APPLICATION NO.	FILING DATE	FIRST NAMED INVENTOR	ATTORNEY DOCKET NO.	CONFIRMATION NO.
09/800,006	03/06/2001	James C. Rush	STE01 P-1086	5256

Office Action Summary

DETAILED ACTION

FIG. 14E

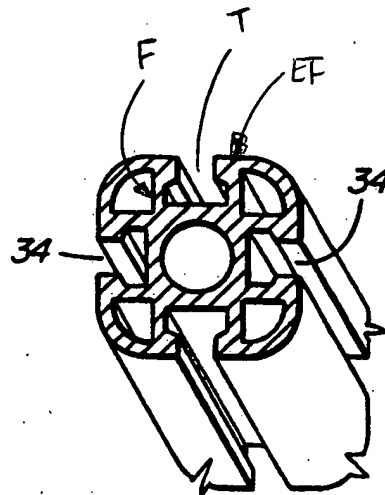
of the open office space in a laterally spaced apart relationship, and an upper portion thereof operably connected with the opposite ends of said overhead beams (10) to support said beams (10) at a predetermined elevation above average user height; at least one of said posts having an X-shaped plan (see figure 14E) configuration defining four mutually perpendicular, outwardly extending flanges (F), each of which has an end face (EF) with a single T-shaped vertical slot (T) extending centrally therealong; at least one of said posts (12) having a Y-shaped plan configuration (see figure 14D) defining three regularly spaced apart, outwardly extending flanges (F2), each of which has an end face (EF2) with a single T-shaped vertical slot (T2) extending centrally therealong (Column 8, lines 57-65); and a plurality of beam-to-post connectors (14,50) attached to the opposite ends of said beams, and detachably retained in said slot (T,T2) of aligned pairs of said flanges (F,F2) on said posts (12) to support said beams (10) on said posts (12) at said predetermined elevation, see the marked attachment. The at least one of said beam-to-post connectors (14,50) of DWILLIES further includes an outwardly projecting stop (14,52) which abuts an uppermost end of an adjacent one of said posts (12) to locate and positively retain an associated one of said beams (10) at said predetermined elevation and also includes at least one partition accessory (20) configured to equip said furniture system for users, and having a mount portion (being the edges of the panel thereof) detachably retained in said slot (22) of one of said posts (12). In reference to claim 81, one of said beams (10) includes opposite side faces, each of which includes a T-shaped hanger slot (22) extending longitudinally therealong; wherein the T-slots (22) are sized and shaped to receive the mount portions (being the
